**COUNTY OF SAN MATEO  
PLANNING AND BUILDING DEPARTMENT**

**DATE:** December 12, 2012

**SUBJECT:** EXECUTIVE SUMMARY: Consideration of a Coastal Development Permit, a Use Permit, a Design Review, a Building Site Exception, a Certificate of Compliance (Type B), and a Certification of a Negative Declaration, to allow the construction of six new industrial buildings on six parcels (four parcels are non-conforming) and to authorize conditional land uses in the Waterfront Zoning District Shoreline area, located between Princeton Avenue and Ocean Boulevard (a paper street) in the unincorporated Princeton area of San Mateo County. (Appeal of the Zoning Hearing Officer's decision to approve the project). This project is appealable to the California Coastal Commission.

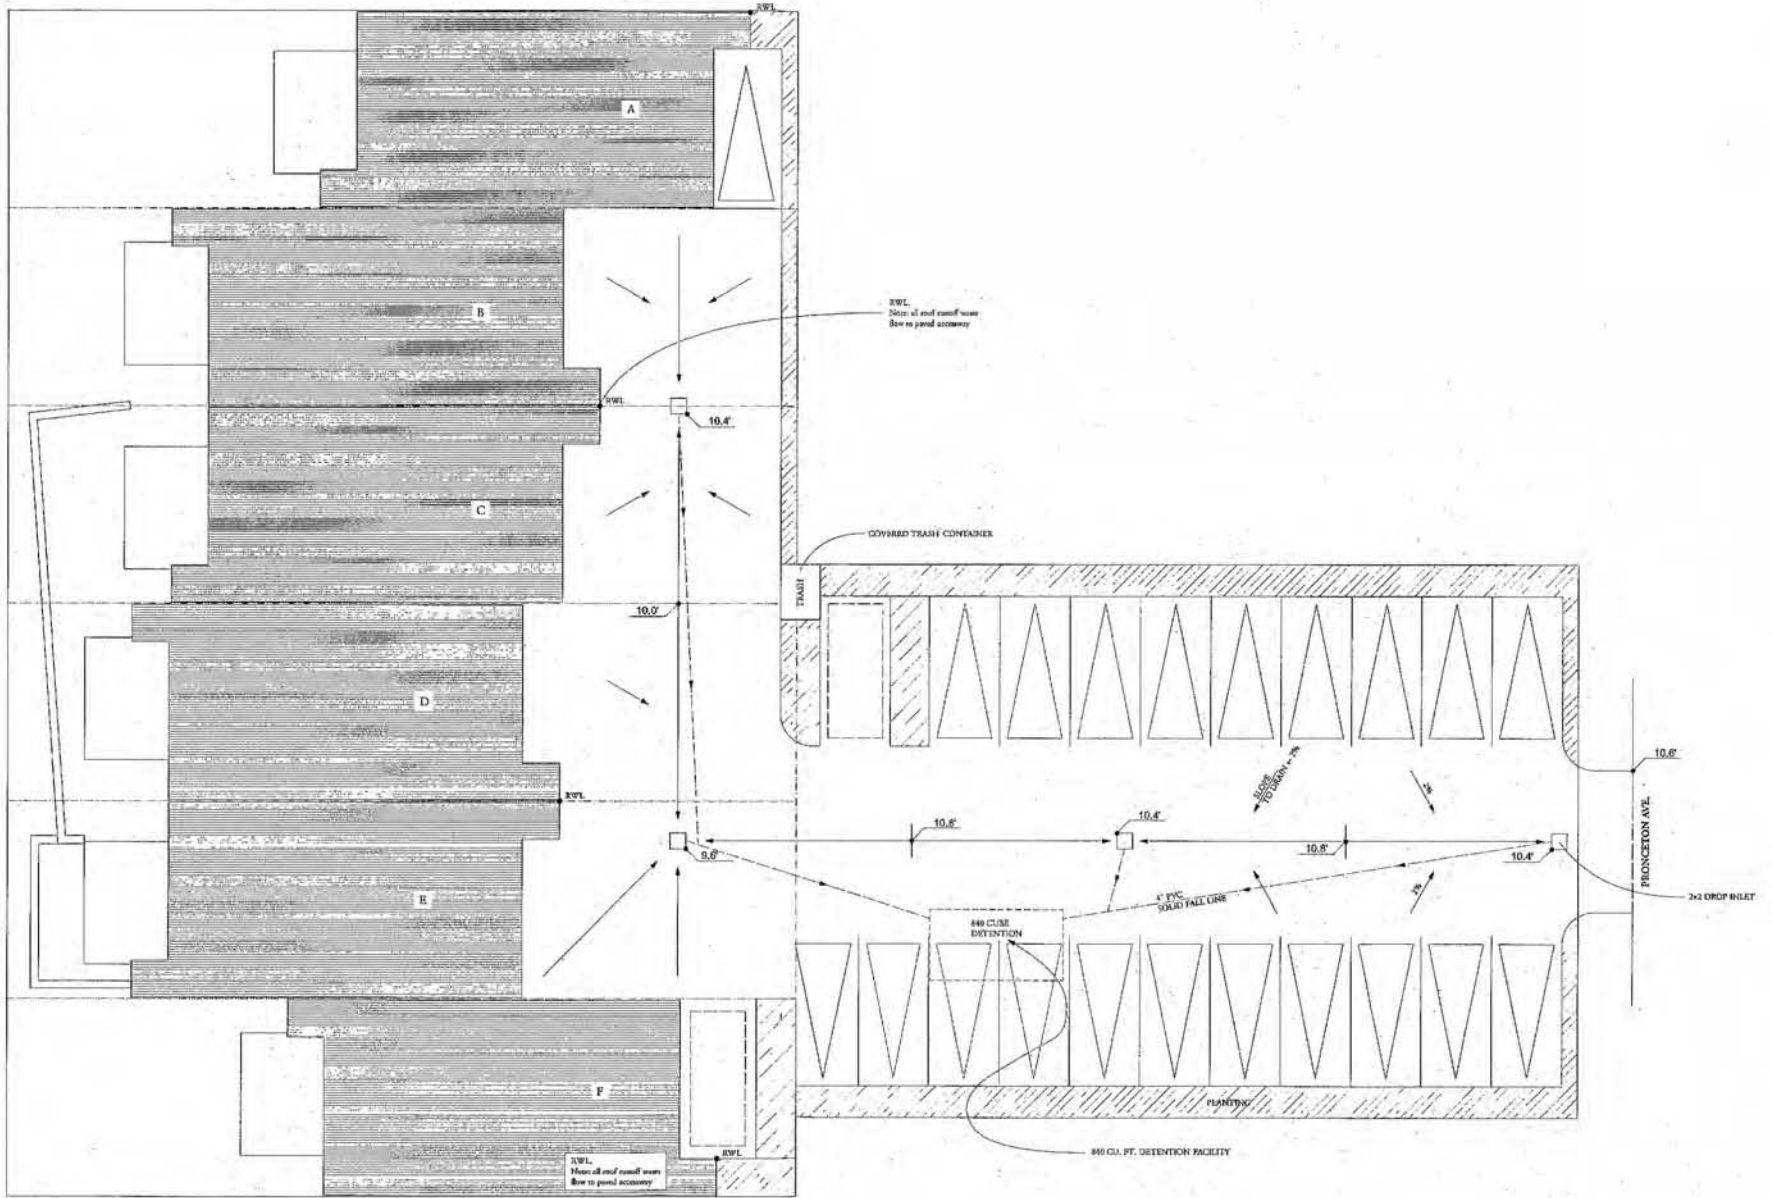
Comment B: "The site plan depicts the seawall as extending in front of three parcels, when in fact, it is only 50 ft. long. Parcel "E" is actually the location of the boat ramp with significantly lower elevation and no seawall. The plan shows Building "E" about 2 ft. from the seawall that is not actually there."

Staff's Response: The site plan has been revised to show the correct location of the sea wall.
